# ADA Site Review and Comments

Project: **Chinsegut Hill Retreat**  
22495 Chinsegut Hill Rd, Brooksville, FL 34601

Summary: **Accessible path slopes/surfaces, accessible parking space, ramps slope, emergency egress accessibility**

Figure 6: Proposed Accessible Parking Location

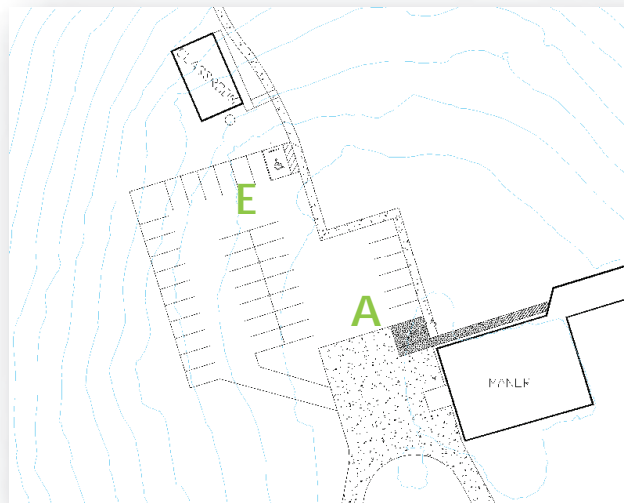
Only 1 of the 2 required accessible spaces are provided based on available parking spaces. While the parking spaces are not delineated in the grass parking area, it is understood these areas are routinely parked for events based on perimeter provided.

**Possible Solution:** Provide an additional ADA parking space in parking area 'E' near the entrance to the retreat area. Alternately, the space may be located next to the existing parking space 'A', or if vehicles are permitted or desired in the retreat area, near the accessible cabin 'K' or at the entry to Dining Hall 'Q'. If no other vehicles are permitted in the Retreat area during retreats, location E is the most compliant area.

**Accessible parking spaces shall be paved (3000 psi concrete, 5" min. thickness is recommended on compacted soil) 12'-0" min. in width and 18'-0" in length designated with a 4" blue painted line on each side of the space with a 5'-0" wide aisle marked with 4" diagonal lines. Aisle and sidewalks shall be 4" thick concrete at a min. of 2500 psi. Spaces shall be marked with an accessible parking sign with violation notice meeting the state statues. (Figures 7 & 8)**

Figure 10: Parking Space

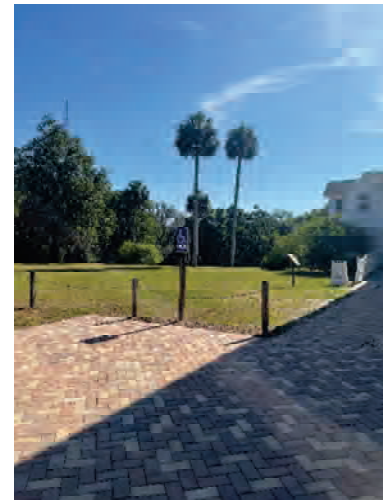
Spaces: 1  
 Parking Type: 90 degree  
 Stall Size: 12'-4" X 19'-11" (12' Width Req. - FAC502.2)

Striping: Hernando County Requires Accessible Parking to be striped  
 Parking Slopes: Cross Slope = <2% (<2% or <1:48 allowed - FAC 406.3)  
 Running Slope = 2% (<2% or <1:48 allowed - FAC 406.2)

- ✘ Pole Signage: **Improper Height: 53"** (<84" & >60" Abv Grade - FAC 502.6.1)  
**Improper Type: Missing Penalty and Statue #** (International symbol of accessibility and the caption "PARKING BY DISABLED PERMIT ONLY." Such a sign, erected after October 1, 1996, must indicate the penalty for illegal use of the space and state statute #. Face of sign to be located 24" min. from face of curb.
- ✚ Aisle Width: 5'-0" (5'-0" Req. FAC502.3.1)  
 Aisle Slopes: <2% (<2% or <1:48 allowed FAC502.4)

**Possible Solution:** Remount existing sign to taller pole so bottom of sign is placed between 60" and 84" above grade. Consider adding required parking striping to comply with Hernando County Standards. (Figure 11)

*Figure 14, Guardrail Height*

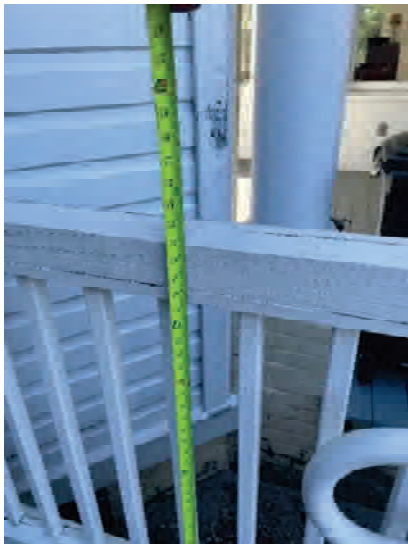
- Guardrail: 41"-42" (Min. 42" Required)
- Picket Spacing: 3.5" (4" Max. allowed)

Figure 26: Accessible Restroom

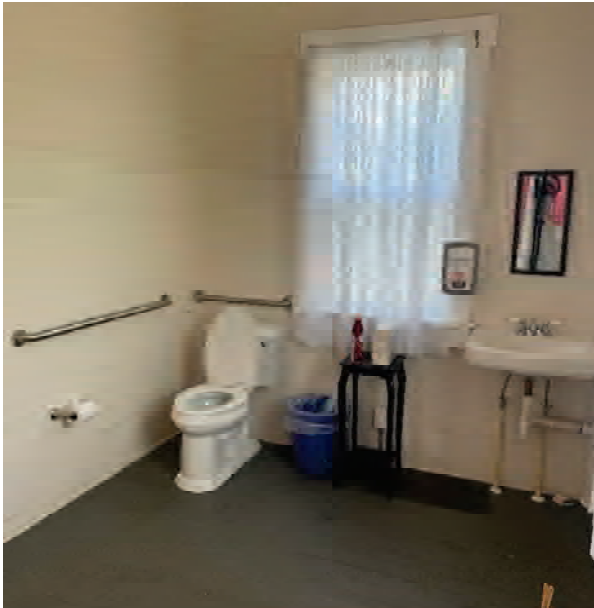
**C:** Accessible Restroom: An accessible restroom is located in the office/foyer space at the top of the accessible ramp at the Main House (C) (Figure 26)

The only change possible in this space is to **install scald protection on the piping under the sink.**

Figures 27 & 28: Water Closet Height, Offset from wall

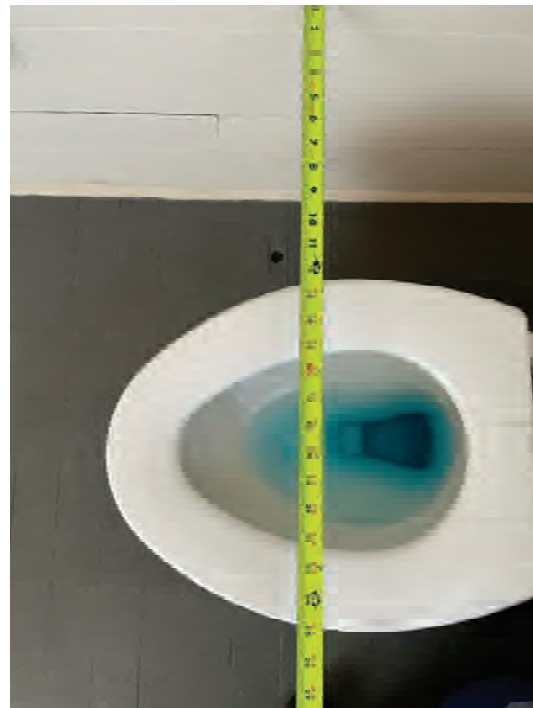
**✗** Water Closet Height: 17.5" (19" Required) (Figure 27)

**+** Side Clearance: 18" (18" required) (Figure 28)  
 Flush Lever on Room Site: Yes  
 Lavatory Depth: 21" (19" required) (Figure 31)  
 Controls: Levers are Historic (Exempt)  
 Height: 33" (32" – 34" Required) (Figure 33)

exempt from the ADA where such improvements are not physically possible or will alter the historic nature of the building. In this case, the restroom has been moderately altered and some improvements are possible. Grab bar and lavatory alterations are not possible without relocating a window and thus, NO CHANGES are possible.

*Figures 29 & 30: Grab Bars*

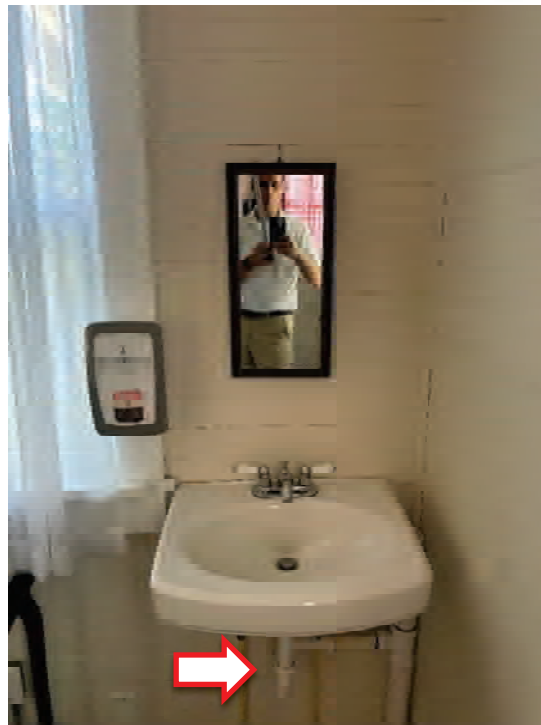
**✗** Grab Bars: 24" Rear 48" Side (36" Rear and 48" Side) (Figures 29, 30)  
 35" High (34" – 36" Allowed) (Figure 26)  
 (Historic Exception Allowed for Window)

Figure 50: Threshold

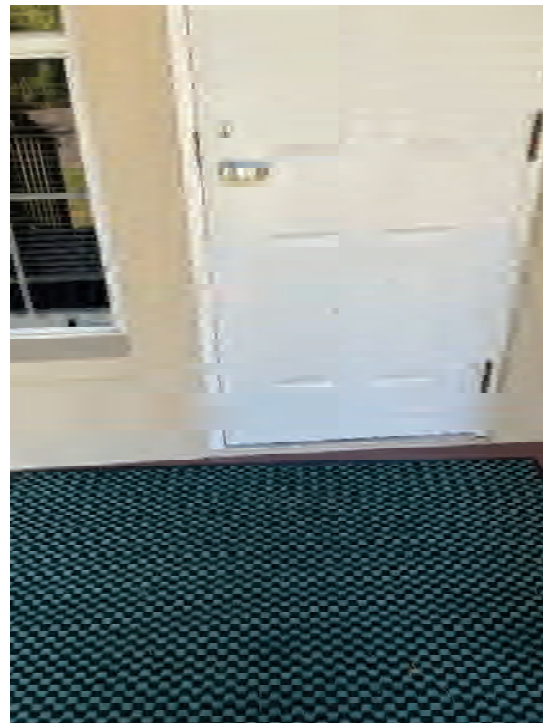
- + Width: 40.5" (Min. 36" Width Required) Building has an estimated occupant load of 6 negating the 44" egress requirement.  
 Length: 12'-6" (Max. 30' allowed)
- ✗ Slopes: <2% Cross Slope & 9.4% Running Slope (Max. <2% Cross Slope and <8% Running Slope allowed)
- + Landing: 60" x 60" <2% Slope (60" x 60" @ <2% Slope Allowed)
- ✗ Guardrail: 38.25" (Min. 42" Required)  
 Picket Spacing: 4-5/8" (4" Max. allowed)  
 Handrail Dia: Non-Compliant Design (1.5" Dia. required FAC 505.6)  
 Handrail Extension: 4" (12" min. Required FAC 505.10)  
 Handrail Clear: Non-Compliant Design (1.5" min. clearance required FAC 505.5)
- + Threshold: .25" change in elevation (.5" allowed with a .5" bevel otherwise .25" maximum allowed FAC 303.2) (*Figure 50*)

Figure 59: Accessible Path L-N

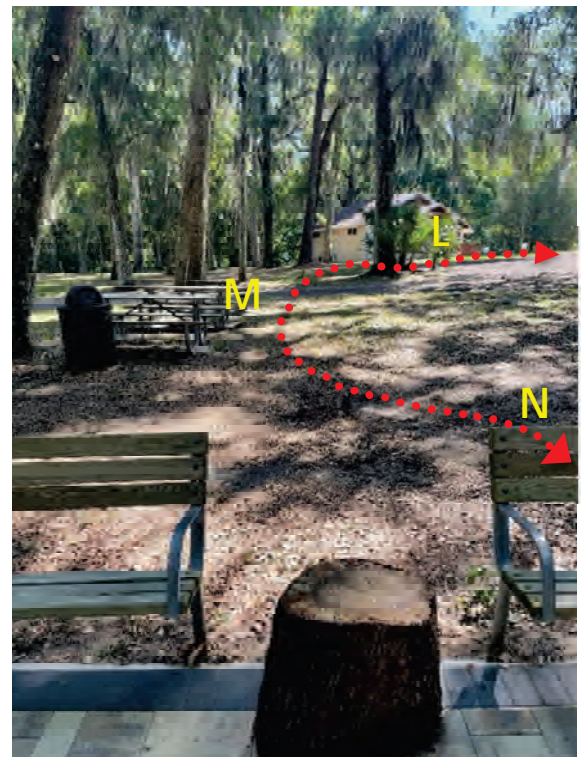
**H-Q Accessible Path:** No Accessible Path exists connecting public spaces on the site to include the Manor House (B), Parking Area (A&E), Classroom Cottage 2 (K), Fire Pit (O) and Dining Hall (Q). Excluded from this requirement are cottages 4-7 which are not required to be on an accessible route as these are not accessible lodging. (*Figure 63*)

**Slopes:**  
 A-E: <2% Slope in the direction of travel  
 E-H: 3%-7% Slope in the direction of travel. (Requires arc in sidewalk path to reduce slope to <5%).  
 H-K: 4% Slope in the direction of travel  
 L-M-N: 4% Slope in the direction of travel  
 N-P-Q: 5% Slope in the direction of travel. (Requires arc in sidewalk path to reduce slope to <5%).

**Possible Solution:** Install a 5'-0" wide concrete sidewalk (min. 4" thick @ 2500 psi with control joints in 5'-0" increments) from the Manor House to Dining Hall (connecting points A, D, E, G, H, K, O and Q). Potential path indicated in (*Figures 56-57*). Path shall be no greater than 5% in slope in the direction of travel with a maximum 2% cross slope which is possible in

the general path shown in Figure 6. The sidewalk can be curved to fit with the dynamics of the land, reduce slope to less than 5%. prevent abrupt changes in direction requiring landings and avoid trees and tree roots. (Figures 57-61, 63)

Figure 63: Accessible Path A-Q

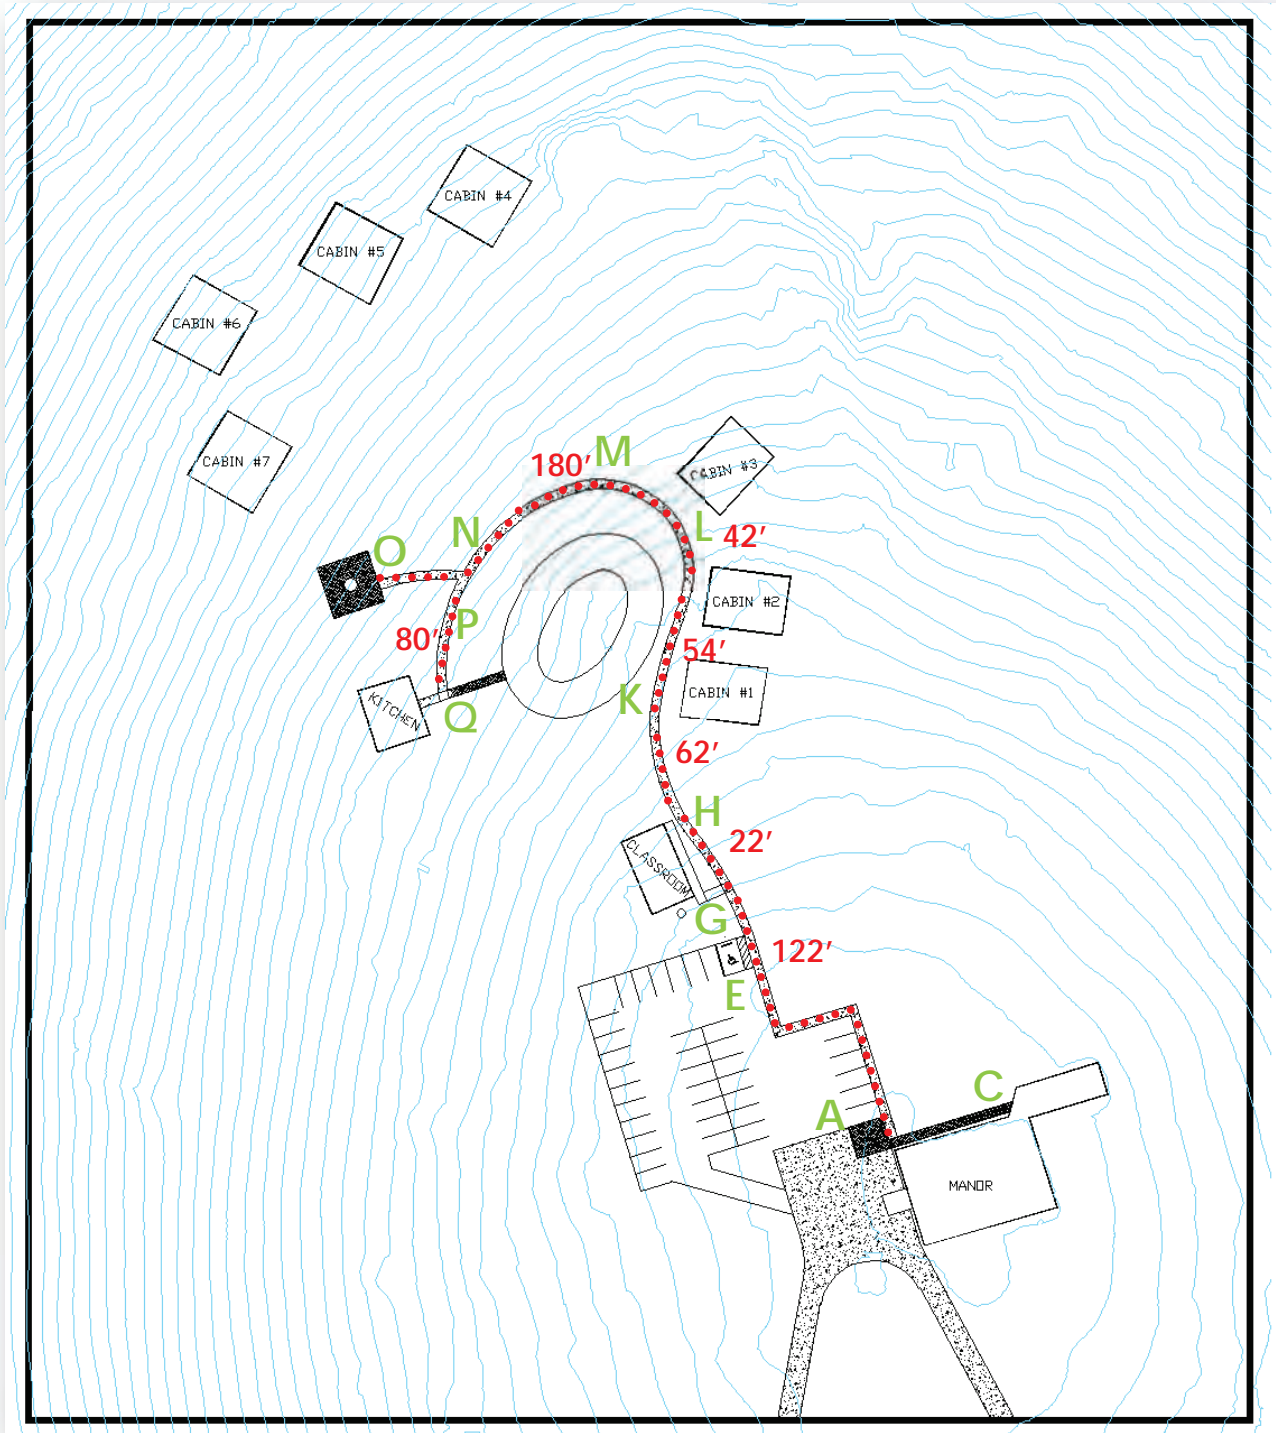
An accessible path is required to have minimum lighting at the exterior of 0.2 Foot Candle (2.15 Lux) at the walking surface. (FBC 1008.2.1 Exception 2). Steps, landings and the sides of ramps shall be permitted to be marked with self-luminous materials in accordance with Sections 1025.2.1, 1025.2.2 and 1025.2.4 by systems listed in accordance with UL 1994. The exterior accessible path, building ramps, porches and landings were not observed in low natural lighting conditions with the exterior lighting fixtures on. It is recommended that the lighting levels be measured at the walking surfaces of the accessible path. *(Figure 63)*

**If lighting levels at the exterior accessible path measure less than 0.2 Foot Candle (2.15 Lux), install full-cut-off lighting fixtures intermittently to provide minimum lighting levels. Note, fixtures can be specified which are motion activated, solar powered with batteries which are ideal for commercial applications and can be mounted to poles. An electrical engineer is recommended for this phase of work.**
